CITY COUNCIL AGENDA ITEM

Subject: PUBLIC HEARING – PRELIMINARY SITE PLAN REVIEW (SP JPLN2021-0028) - Proposed Golden Villas One Family Residential Cluster, South side of Square Lake, West of Dequindre (PIN 88-20-12-200-031 & 88-20-12-200-035), Section 12, Currently Zoned R-1C (One Family Residential) District

Preliminary Site Condominium Cluster Review For City of Troy, Michigan

Project Name:	Golden Villas
Plan Date:	February 28, 2022
Location:	South of E. Square Lake, west of Dequindre
Zoning:	R-1C, One-family Residential District
Action Requested:	Preliminary Site Condominium Cluster Approval
Required Information:	Deficiencies noted.

FRONT ELEVATION

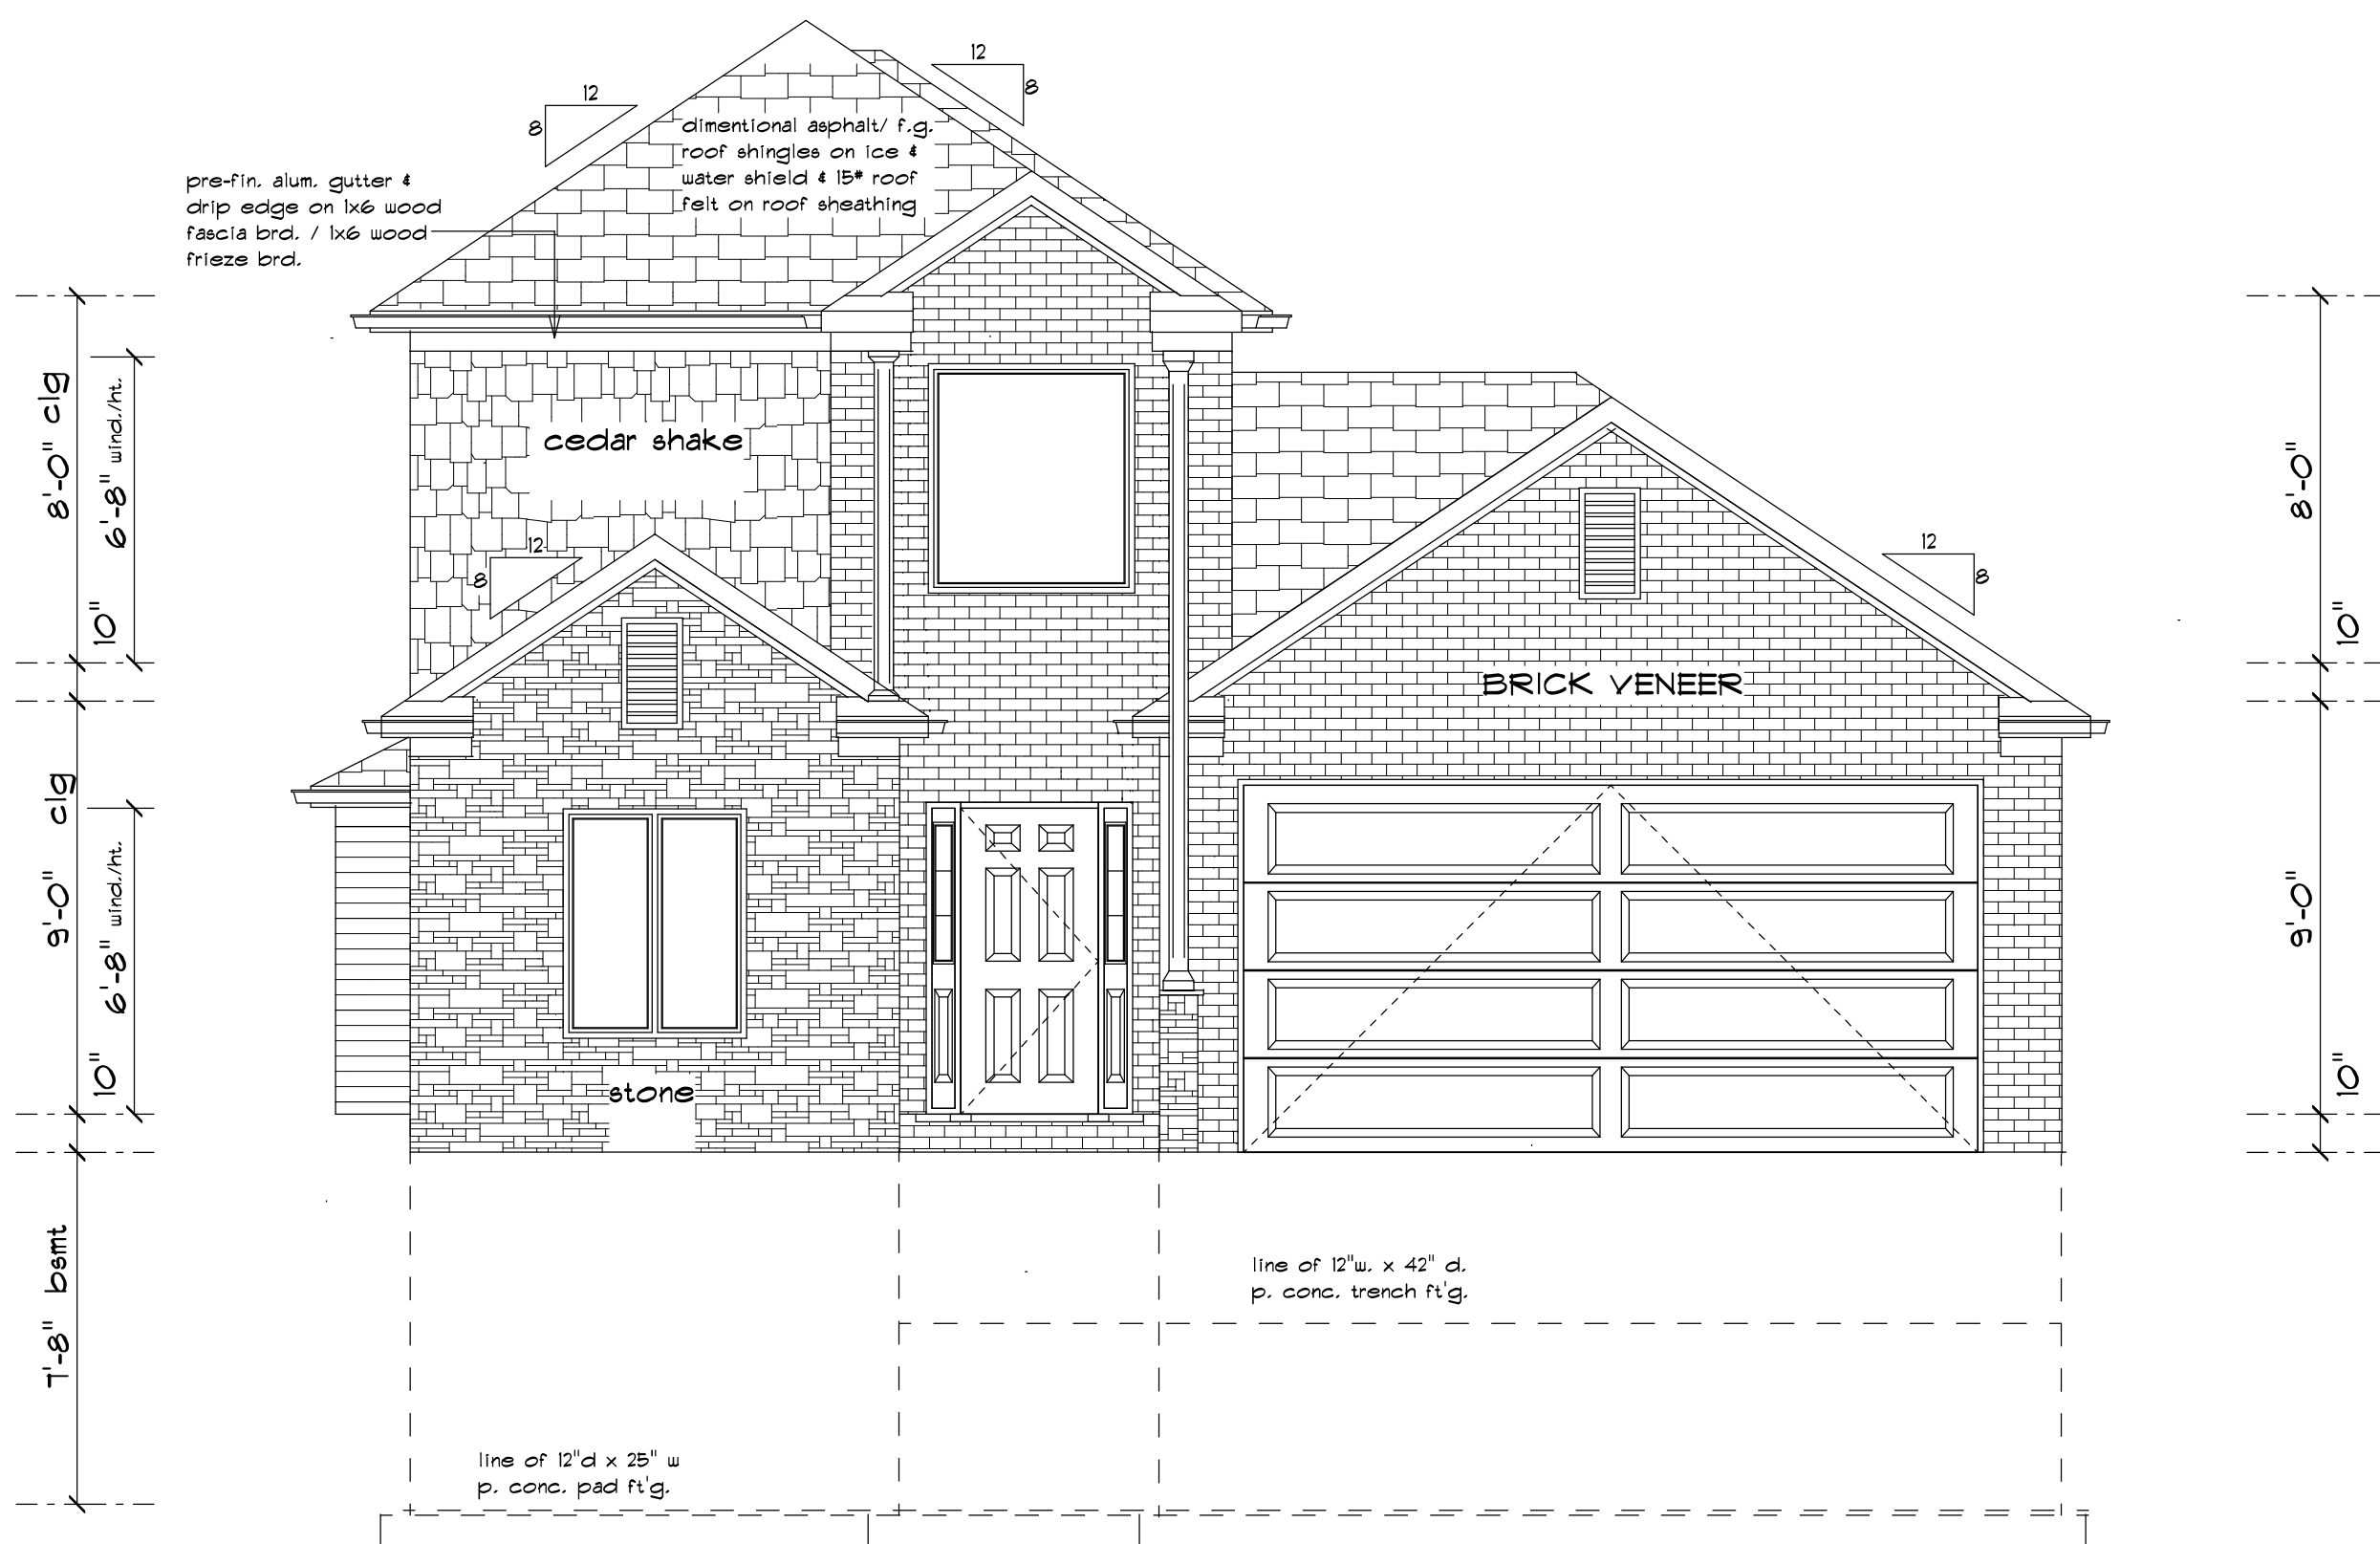
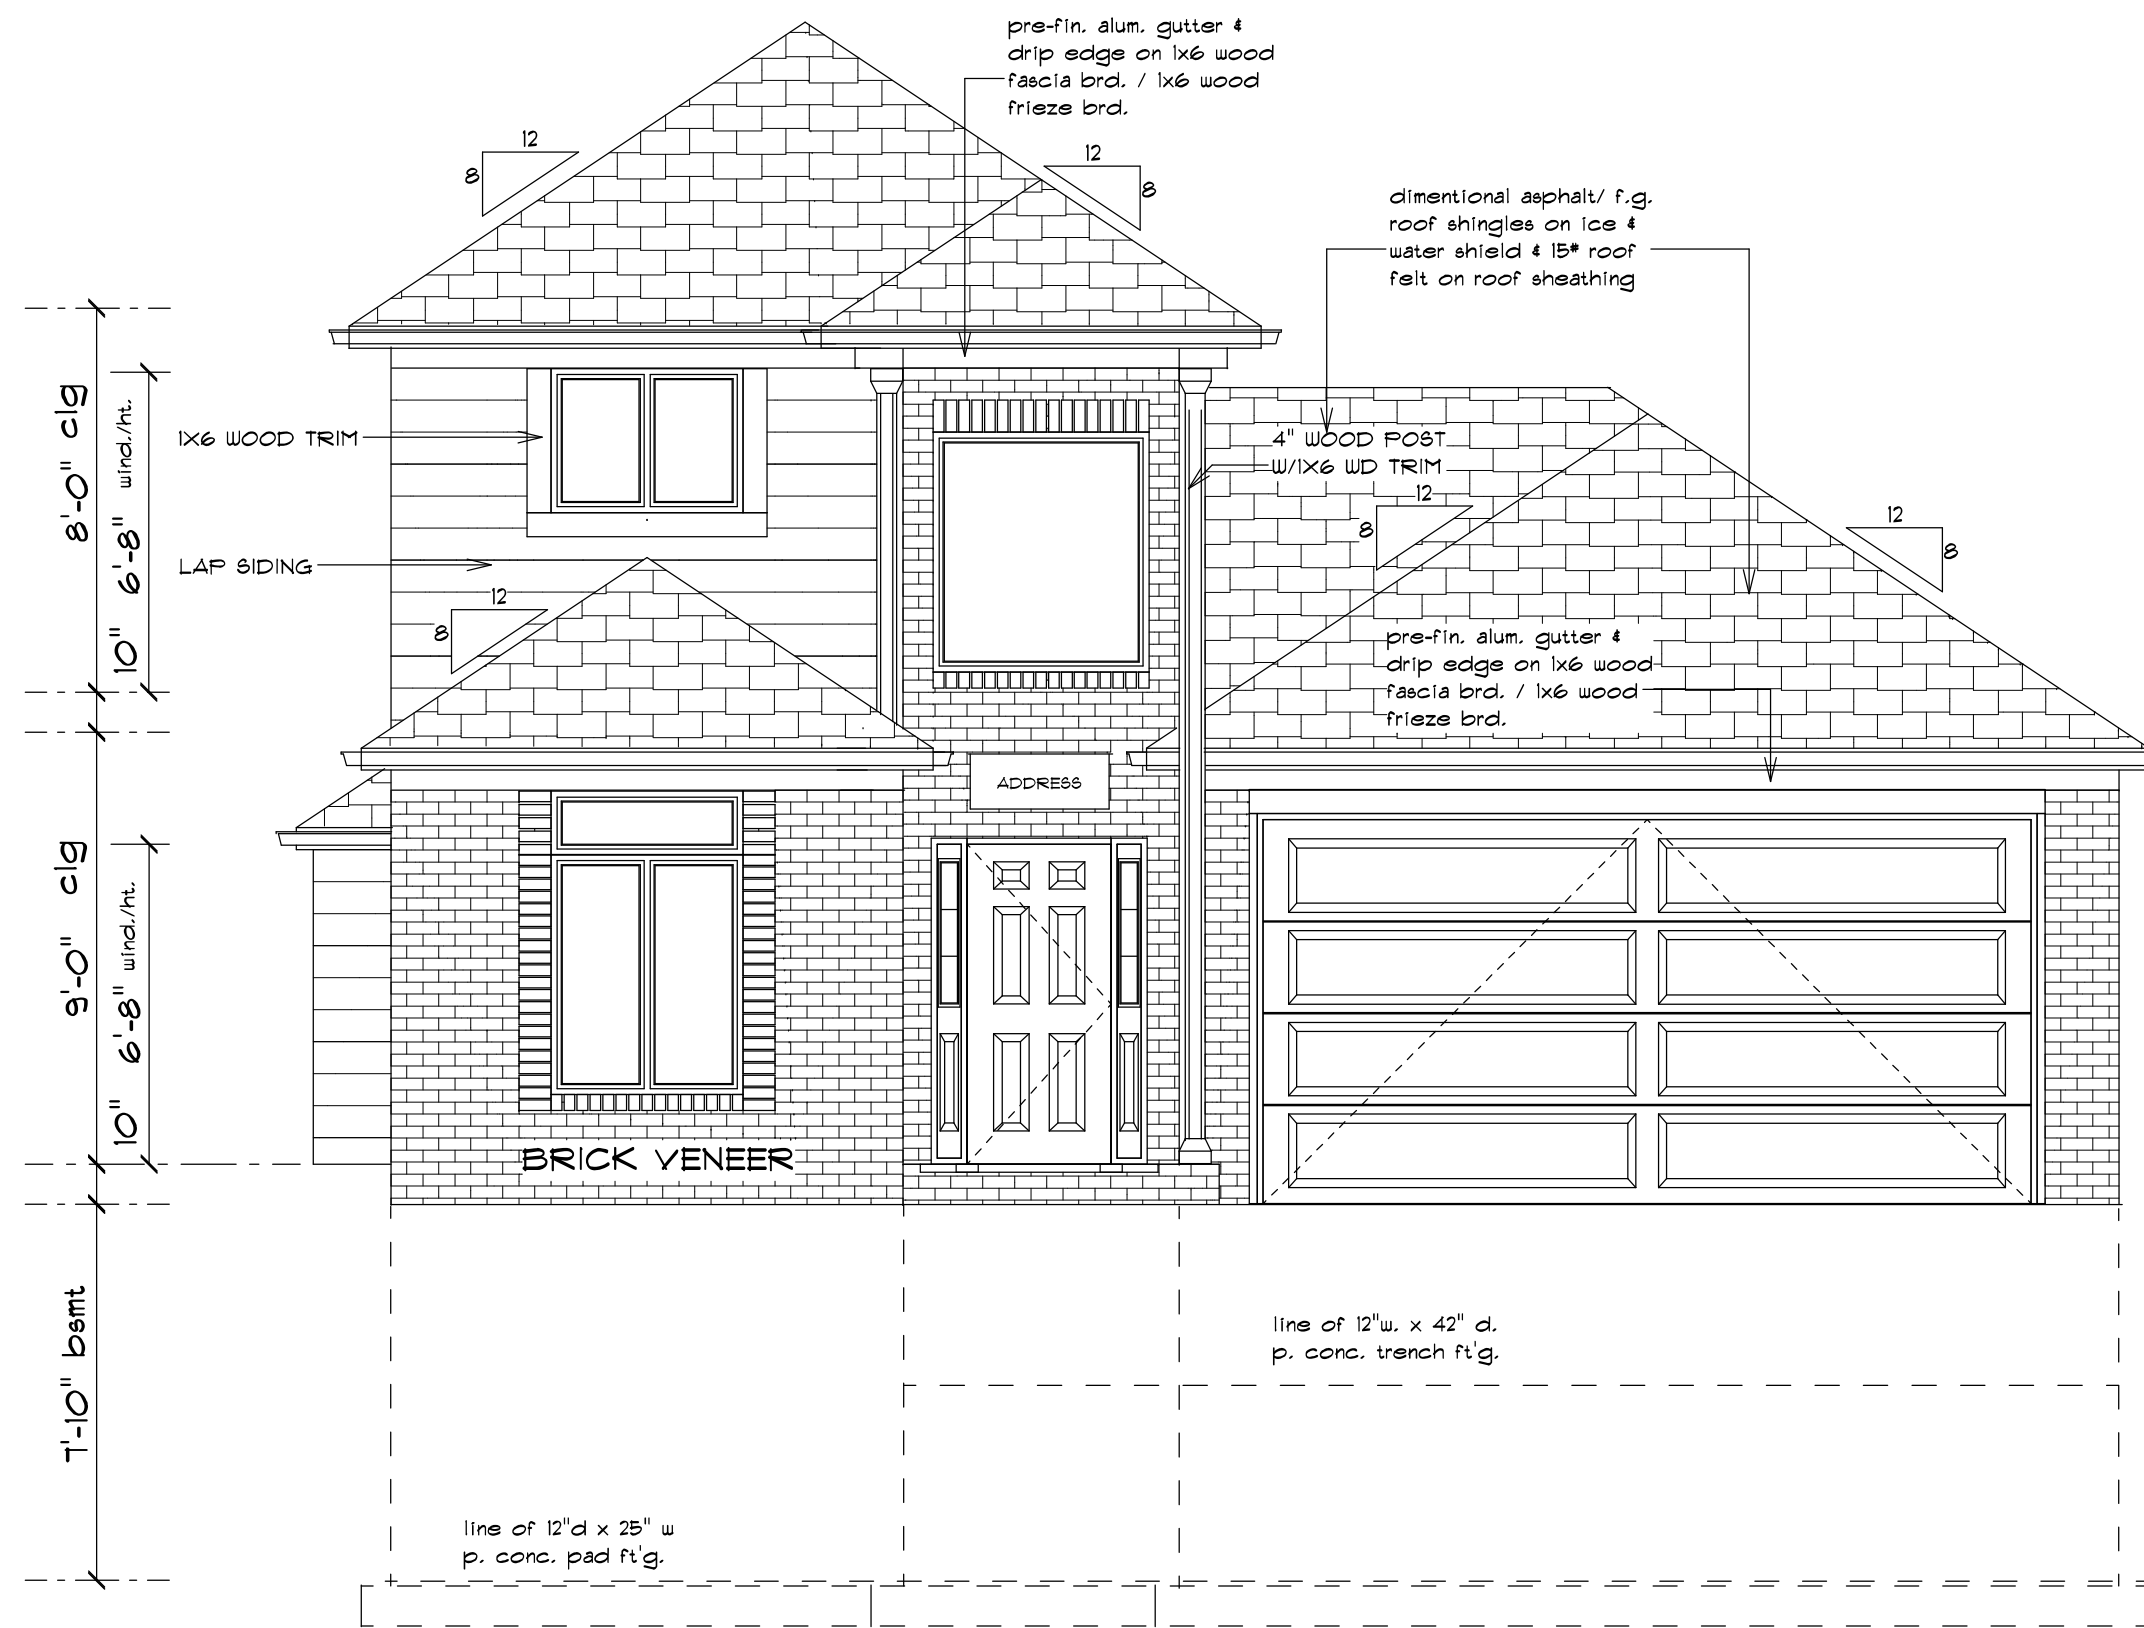
The applicant has submitted one housing options with a square footage up to 1,900. The applicant shall supply additional housing elevation options. Materials include brick, stone, and cedar veneer.

Items to be Addressed: Provide additional housing elevation options

The petitioner submitted a Landscape Plan with the additional twenty (20) trees along Square Lake Road. The petitioner has provided numerous additional housing elevation options which were included with the site plan. The petitioner has agreed that the exterior elevations will not include vinyl siding. An Open Space Preservation Agreement will be required to be submitted and approved prior to Final Site Plan Approval.
